Service data bulletin

Instrument: GDS101
SDB: Keyboard variations

SPACER VARIATIONS IN KEYBOARD VER D

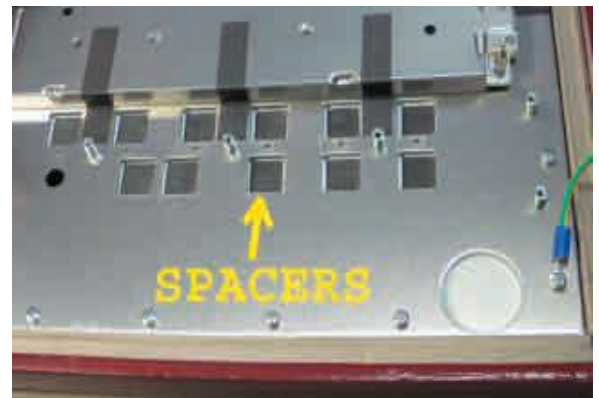
There are two types of buttons on the GDS101 keyboard ver D.

- 1: White buttons
- 2: Blue buttons.

Blue buttons were used in production in 2005.
Serial no from 052387 to 052450

In front of buttons there is a spacer.
(Between buttons and overlay of front.)

Because of differences in height of buttons there is a need of an additional spacer with the blue button keyboard
